Fimiston Gold Mine Operations Extension (Stage 3) and Mine Closure Planning: Revised Proposal Fimiston South Project

Revised Response to Public Submissions Fimiston South Project

**4 December 2024
EPA Assessment 2354
DWER ref: APP-0000265**

Revision 2.3

Figure 1 *Fimiston E. praecox* populations

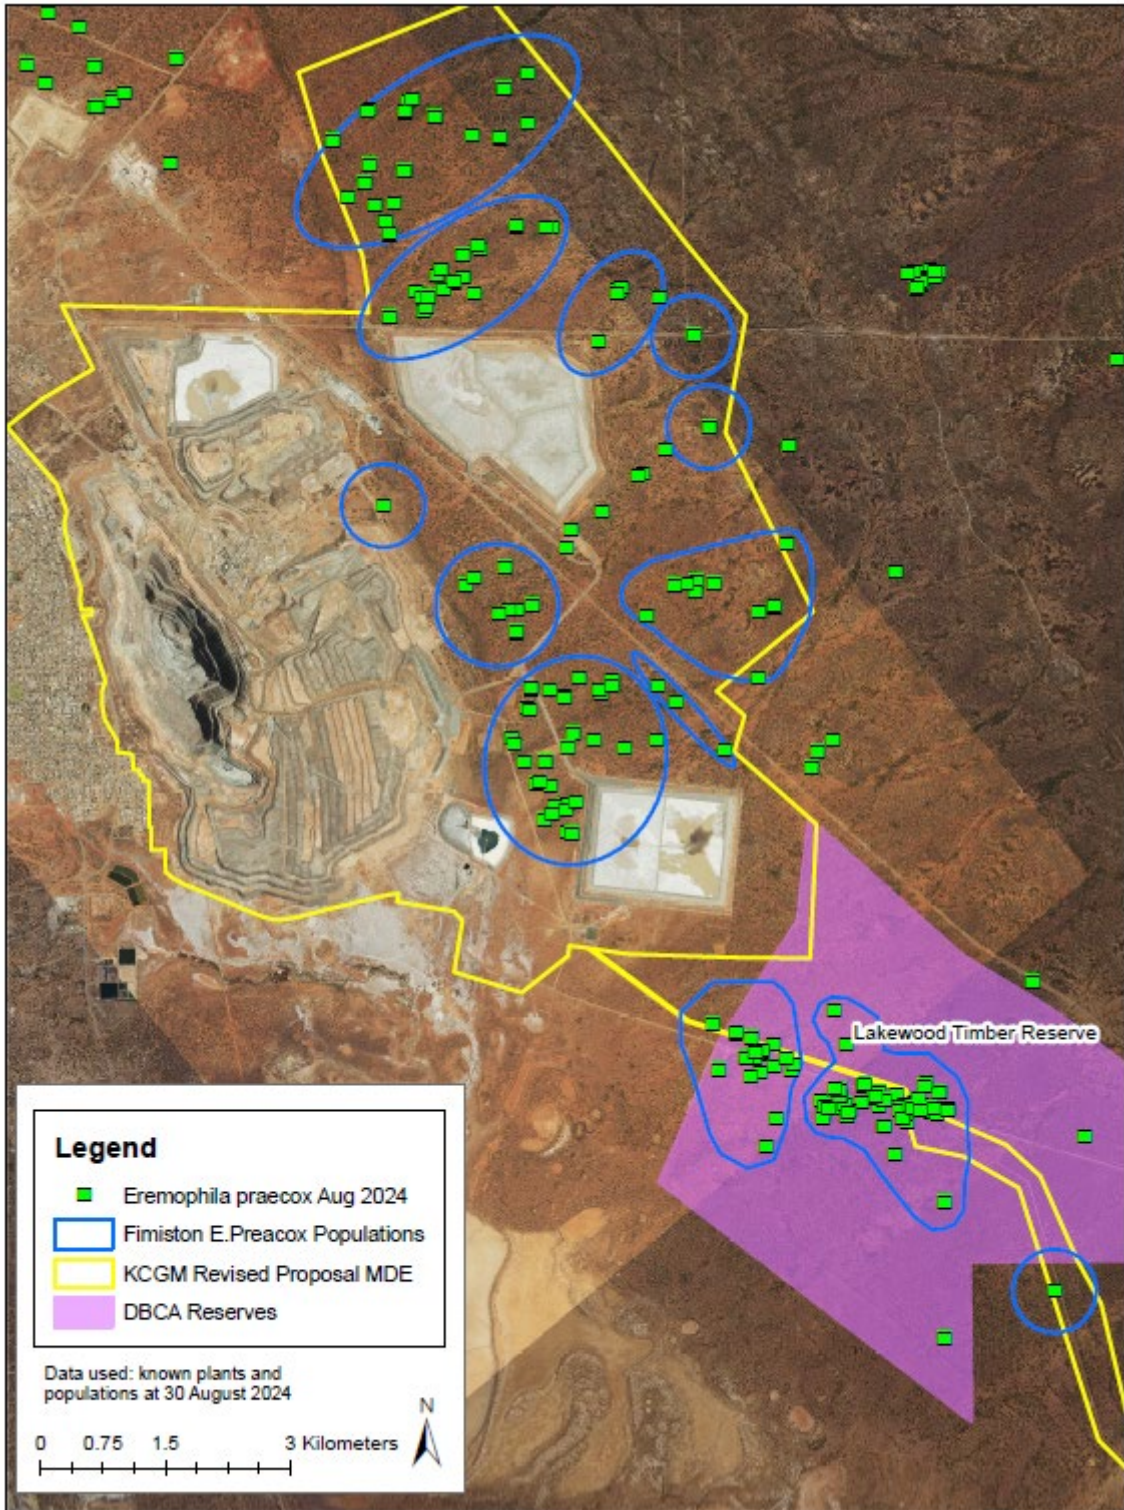
| No. | Submitter | Submission and/or Issue | Response to Submission |
|-----|-----------|--|--|
| 4 | DWER | <p>Cumulative impacts to <i>Eremophila praecox</i> include 22 plants from two previous clearing permits at Northern Star (ERD, Table 32.). Section 6.5.5.3. of the ERD states "13 plants [of <i>E. praecox</i>] are proposed to be impacted by clearing". This totals 35 plants to be cleared from the combined proposal. However, Figure 22 (ERD) shows <i>E. praecox</i> records in excess of 35 within the proposed disturbance area. Recalculation of proposed impacts to values may need to be undertaken to provide confidence in impact assessment.</p> | <p>The drafting of the ERD in relation the <i>Eremophila praecox</i> was not clear when referring to the number of individual plants versus number of populations in the area, the MDE and the proposal footprint. Within the MDE there are 13 populations of <i>E. praecox</i> with 186 individuals within the MDE, of which 126 are in proposed disturbance footprint.</p> <p>Clearing of <i>E. praecox</i> for other known projects amounts to 22 plants and when combined with the plants to be cleared under this proposal is a cumulative impact of 148 plants (126 + 22).</p> <p>The <i>E. Praecox</i> species is most frequently recorded in clay loam soils in Eucalyptus and/or Allocasuarina woodland with a variable understorey, frequently with Acacia. <i>E. praecox</i> is recorded widely in Conservation Reserves (193 plants; 26% of current population; 33% of population after</p> |

| No. | Submitter | Submission and/or Issue | Response to Submission |
|-----|-----------|--|---|
| 9 | DWER | <p>Based on the information provided in the ERD, it is difficult to assess impacts to priority species <i>Eremophila praecox</i> (P2). An additional investigation has been carried out and cumulative impact assessment has calculated direct impacts to 7% of the known local population (including 3% from this assessment) (ERD, p.122). However, information provided in the ERD is contradictory at times. For example, Figure 22 does not confirm values presented in the Assessment of Impacts section (6.5.5) of the ERD. Re-assessment of direct impacts to <i>E. praecox</i> should be undertaken to provide confidence and should be updated accordingly to provide clarity.</p> | <p>The drafting of the ERD in relation the <i>Eremophila praecox</i> was not clear when referring to the number of individual plants versus number of populations in the area, the MDE and the proposal footprint. Within the MDE there are 13 populations of <i>E. praecox</i> and there are 186 individuals. Of these 126 are within the proposal footprint.</p> <p>The <i>E. Praecox</i> species is most frequently recorded in clay loam soils in Eucalyptus and/or Allocasuarina woodland with a variable understorey, frequently with <i>Acacia</i>. <i>E. praecox</i> is recorded widely in conservation reserves including the Kurrawang Nature Reserve, Lakewood Timber Reserve and Bullock Holes Timber Reserve (Phoenix 2020).</p> <p>The total number of populations recorded within a 100km radius of Fimiston is 62 (excluding the 13 populations that intersect the MDE) and currently known number of plants is 729 (Phoenix 2024). Of those individuals, 193 (26%) occur within Reserves.</p> <p>A maximum of 126 plants are likely to be removed for this proposal, representing 17% of the currently know number of plants. Of the 13 populations within the MDE, none of the populations will be totally cleared. There will be some plants remaining from each population. KCGM will be mindful of this and have continue to implement existing robust internal controls in place to minimise clearing and prevent unnecessary clearing of <i>E.praecox</i> where ever possible.</p> <p><i>E praecox</i> populations have been found across an area of 31,400 km² or 3,140,000 ha. The removal of 1580 ha of <i>E. praecox</i> habitat equates to 0.0005% of the known range.</p> |

Implementation of the proposal will result in a direct impact of clearing up to 126 of *E. Praecox* plants. The recent mapping (Phoenix, 2024) has recorded 729 individual plants in a 100km radius of the Fimiston Proposal. There are 75 populations recorded of which 13 are within the MDE. Of the populations within the MDE individual plants will be removed but no population will be removed in its entirety.

Figure 3 Marginal foraging and dispersal habitat for Malleefowl

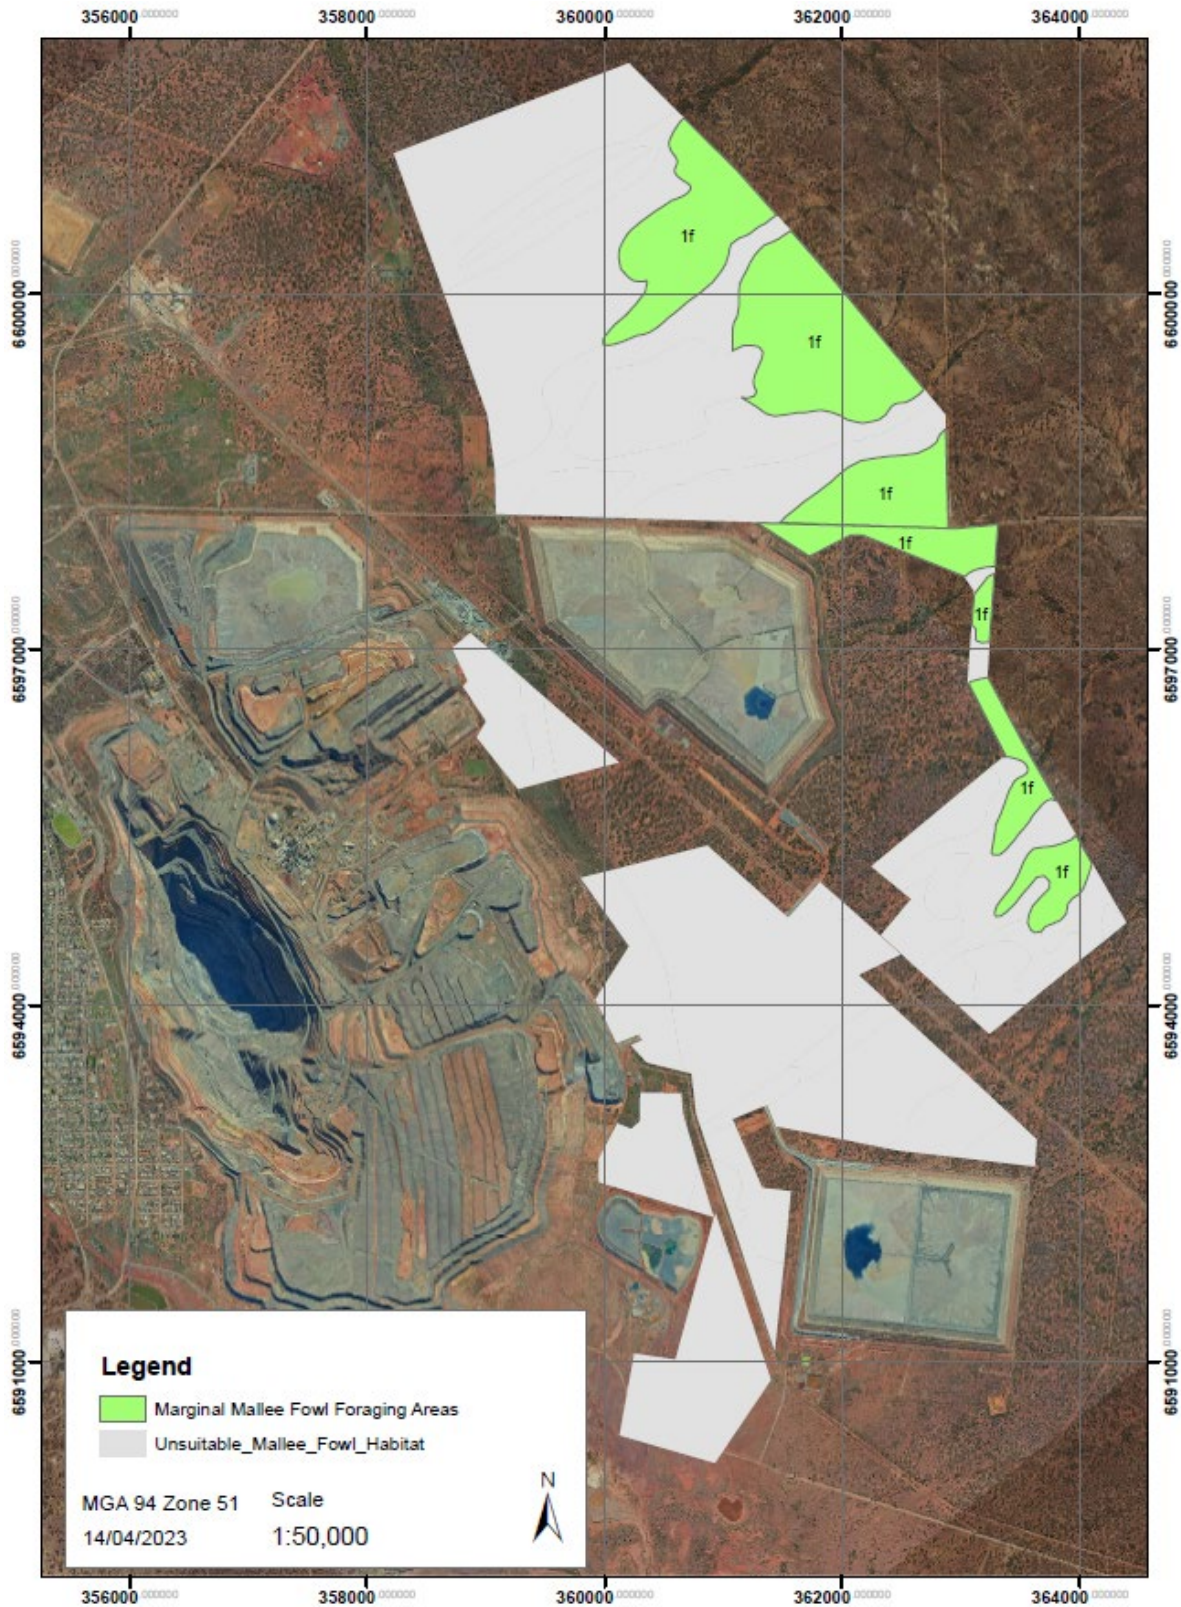
| No. | Submitter | Submission and/or Issue | Response to Submission |
|-----|-----------|--|--|
| 16 | DWER | It is unclear what areas the 'Malleefowl extrapolated foraging and dispersal habitat' is referring to (Table 38, Figure 26). The location of the extrapolated habitat across the Proposal area, and the method of calculating this habitat, should be clarified. | <p>The extrapolated areas refer to a survey undertaken by Phoenix Environmental Services in 2022. The extrapolated areas were based on the broad vegetation types 1) Open woodland, 2) Shrubland and 3) Rehabilitation and located in the central section of the Proposal area.</p> <p>In 2023, Holm & Associates undertook a new detailed assessment (integrating additional information such as soil types) of the proposed MDE and a ground truthing survey to validate the data that was presented in the Phoenix (2022) survey report (Appendix J, Figure 3 of the ERD) for suitable foraging and dispersal habitat for Malleefowl. This survey confirmed that there was no evidence of the presence of Malleefowl in the central MDE (clay rich floodway area) and the potential foraging and dispersal habitat for Malleefowl was determined to be marginal, as</p> |

| No. | Submitter | Submission and/or Issue | Response to Submission |
|-----|-----------|--|--|
| | | | <p>The marginal habitat within the Revised Proposal footprint (441 ha) represents approximately 7% of the potential marginal Malleefowl foraging and dispersal habitat within the MDE.</p> <p>Figure 3 and Table 3 show the marginally suitable habitat (1f) for Malleefowl foraging and dispersal. The turquoise area in Figure 3 is area identified as the marginal foraging and dispersal habitat by Holm (2023). Areas are provided in Table 3 in 4.3.1.2 of this document.</p> |

| No. | Submitter | Submission and/or Issue | Response to Submission |
|-----|-----------|---|---|
| | | | <p>defined by the Holm & Associates Survey (2023), and along the eastern edge, linked to external areas. See Figure 3 of this document for Holm's mapped Malleefowl habitats.</p> <p>The Holm & Associates survey (2023) confirmed that there was no recent evidence of Malleefowl in the survey area. The comprehensive re-assessment of the area by Holm & Associates (2023) further concluded that the area (1f) defined as suitable for foraging and dispersal (Table 38 of the ERD), is actually considered to be <u>marginally</u> suitable at best with a habitat assessment score of 5.09 (out of 10). Noting that where scores above 5 are considered marginal habitat for breeding and survival, scores of above 7 are considered critical habitat for breeding and survival of Malleefowl. The verification survey (Holm & Associates 2023) determined that 451 ha of the 2,303 ha surveyed was found to be "<i>marginally suitable for foraging and dispersal</i>" for Malleefowl.</p> <p>Section 6 of Holm & Associates (2023) details the survey methodology and Table 3 within the report provides the justification for the habitat calculations.</p> |

In response to the request for further information from the EPA, Holm & Associates were commissioned to undertake a ground-truthing survey over the relevant areas for the Fimiston Project (Figure 3, Appendix J). The results from the field survey in 2023 indicated that there was no evidence of recent Malleefowl activity and there was a single "long unused" nesting mound, as characterised by the National Malleefowl Recovery Team (2016).
